The following are the technical modifications to the specification of the tender no. HRP/NFC/PT/TPT/CAP/10361.

The following modification to the tender specification are made and to be read point wise as given below and supersedes the specification as and wherever applicable.

10) Pg. no. 61 of 159:

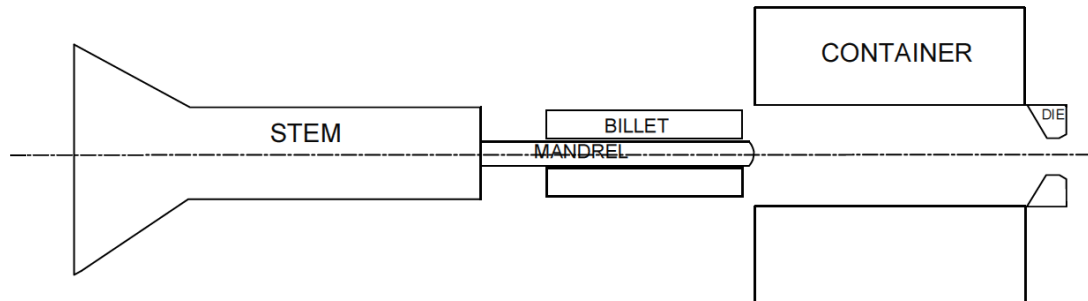
Runout Table

Shall be read as:

Others
